TOWN OF STONEWALL WASTEWATER TREATMENT LAGOON UPGRADE

MWSB #1374

ADDENDUM No.4

ADDENDUM NUMBER: 4
DATE OF ISSUE: August 15, 2017
ISSUED BY: Brian McIntosh, P.Eng.
Telephone: 204.954.6876

DRAWING DESCRIPTION:
PROPOSED 400 FORCEMAIN
PLAN/PROFILE
STATION 6+70 TO STATION 9+80
(SHEET 3 OF 4)

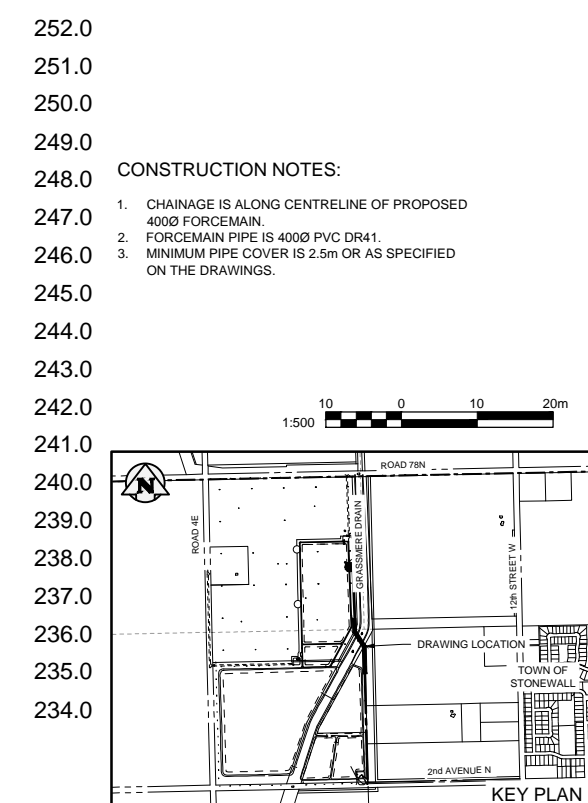
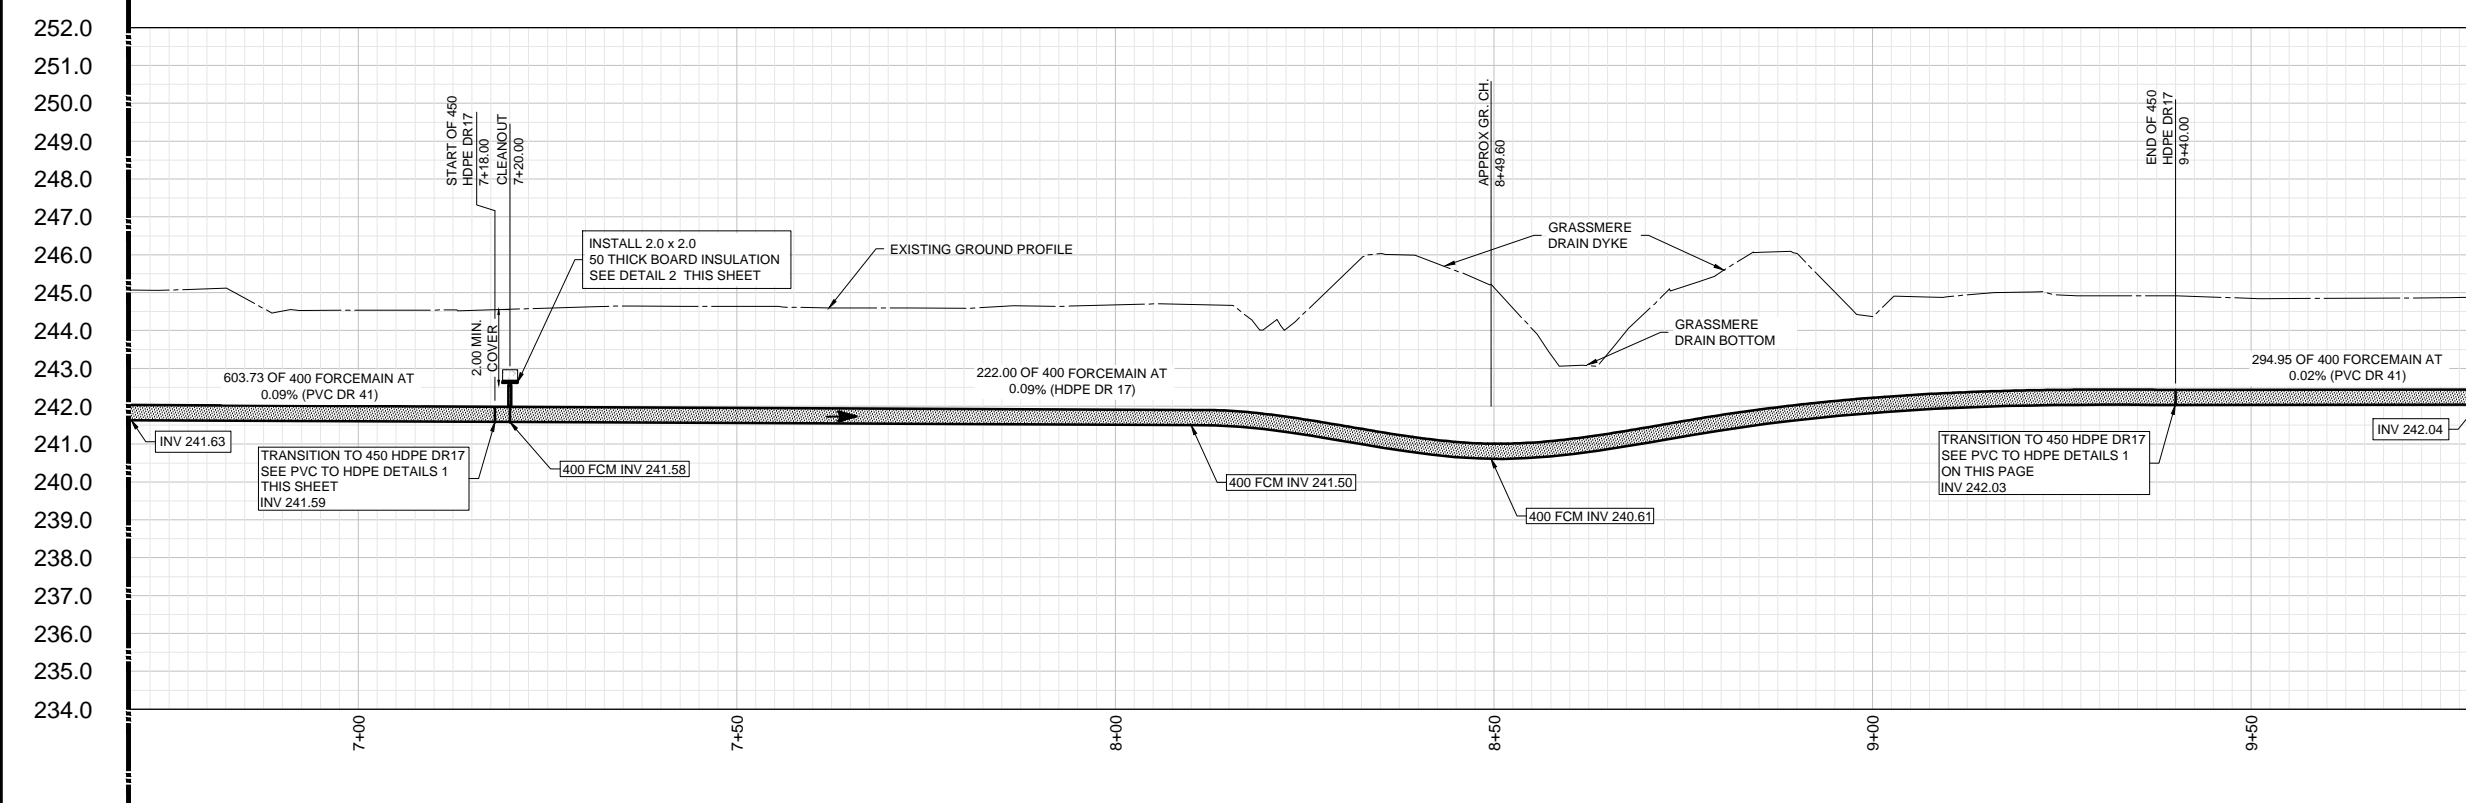
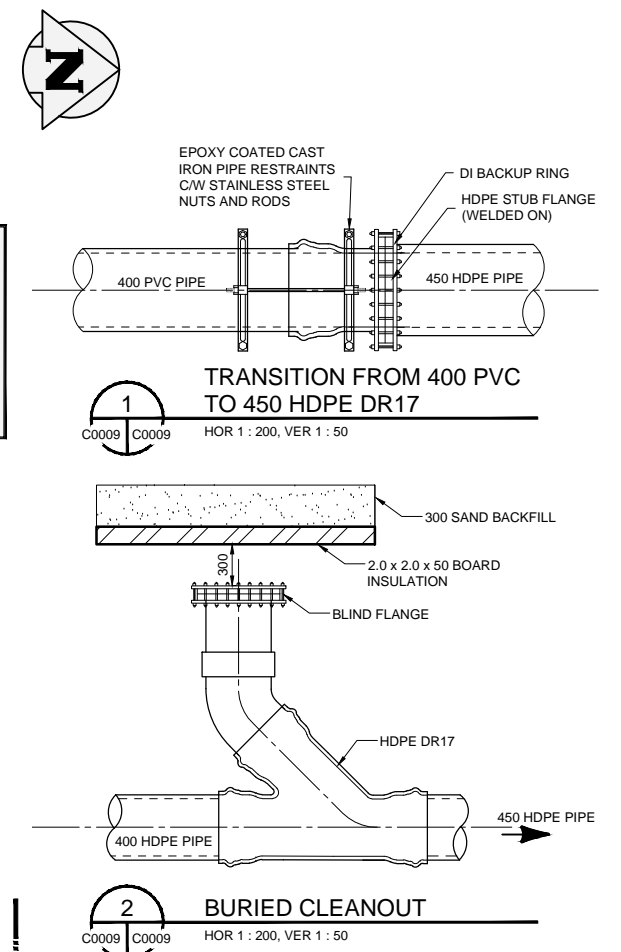
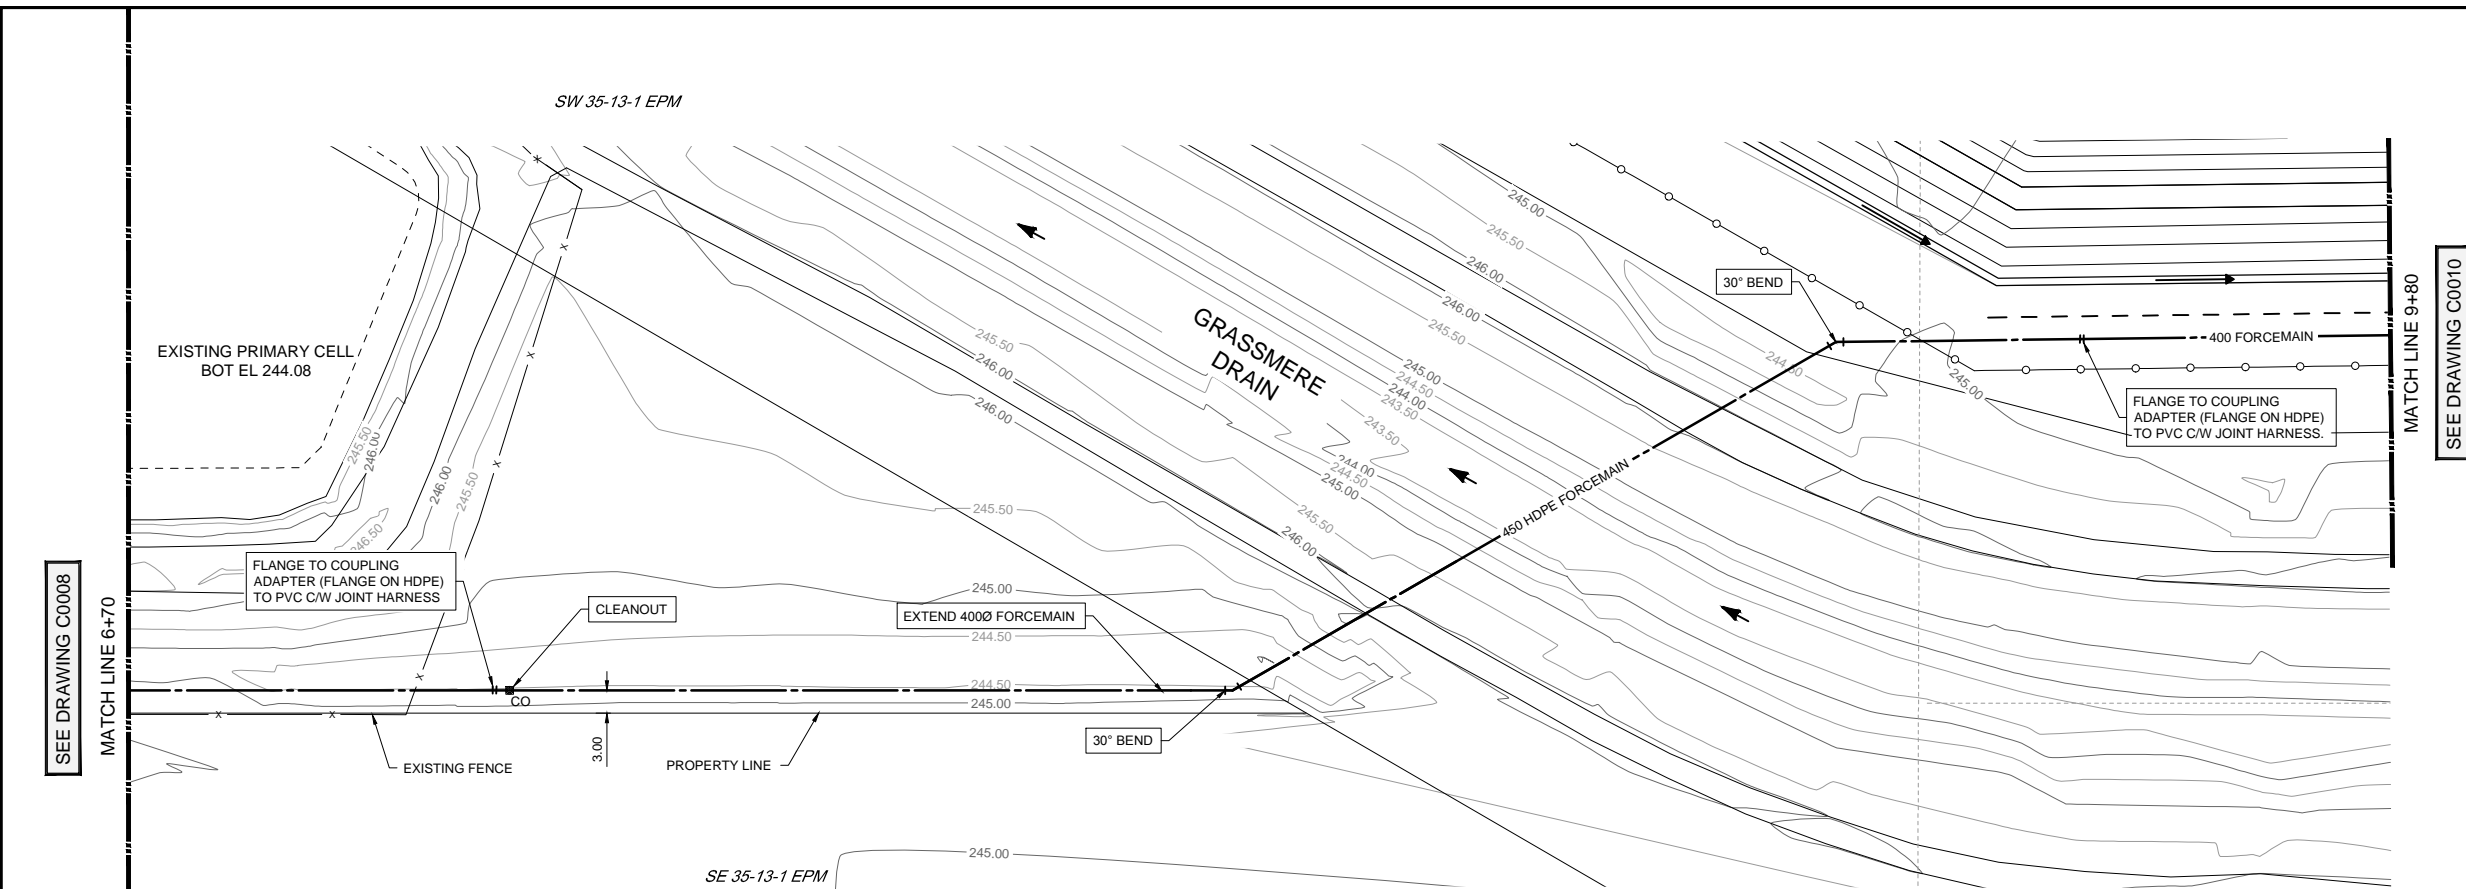
Drawing C0009 R2 is to replace the existing Drawing C0009 R1.

The transition from 400 mm PVC DR41 to 450 mm HDPE DR17 has been shifted from STA 8+10.00 to STA 7+18.00. The cleanout wye is to be installed as part of the HDPE.

6 1200mm MANHOLE

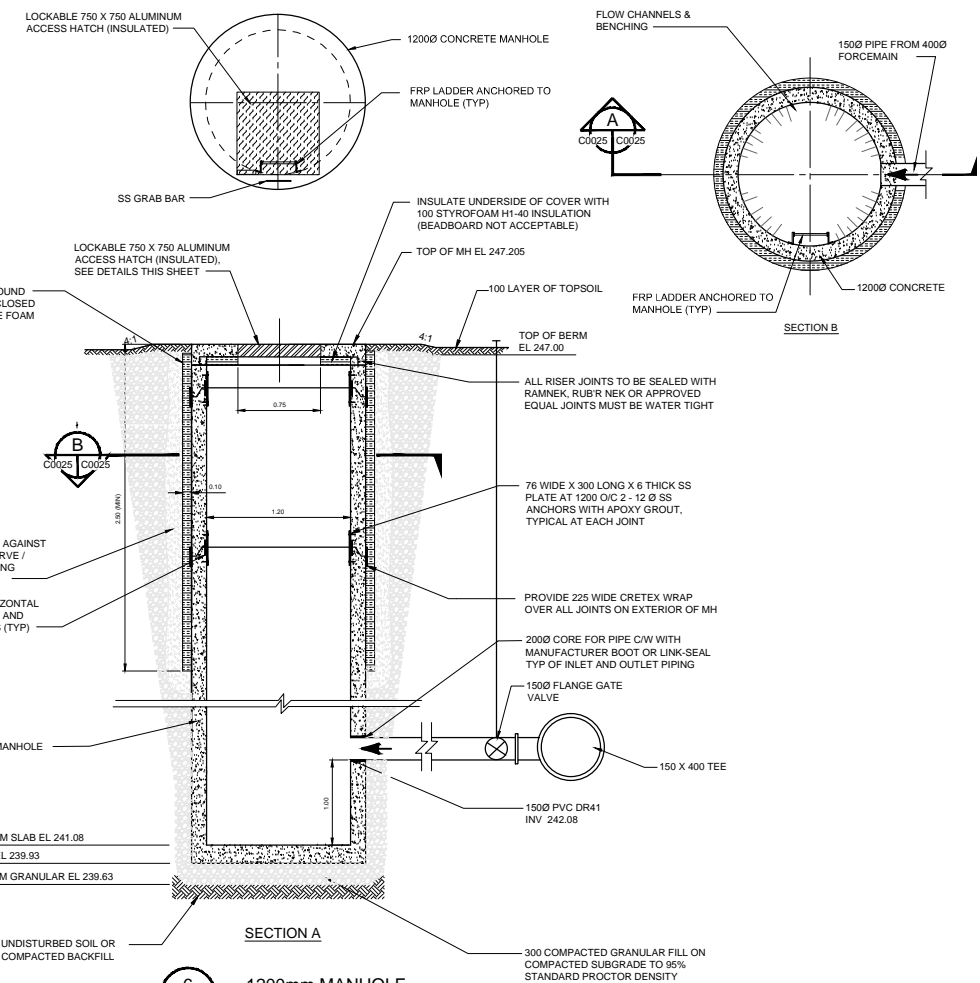
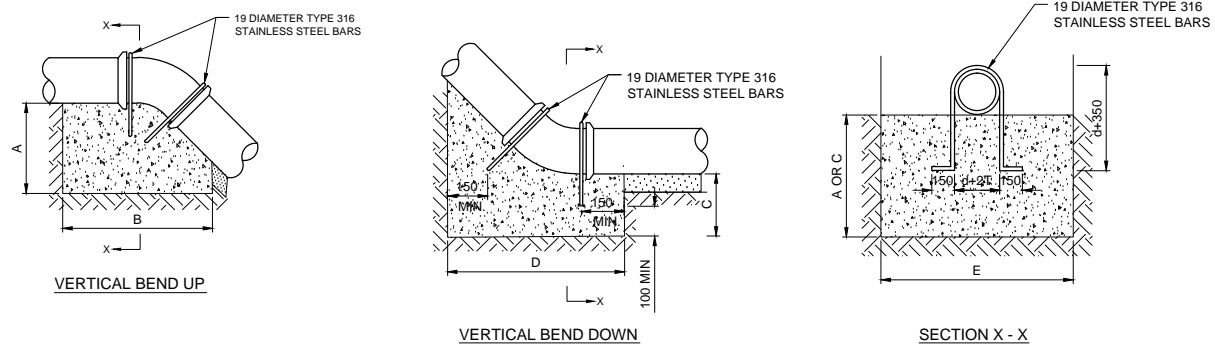
Q.: Is there a detail on the new pumped drain manhole or does the pipe just drain into it?

A.: The pipe just drains into the manhole. The revised drawing C0025 R1 showing the new manhole detail is attached to this Addendum.
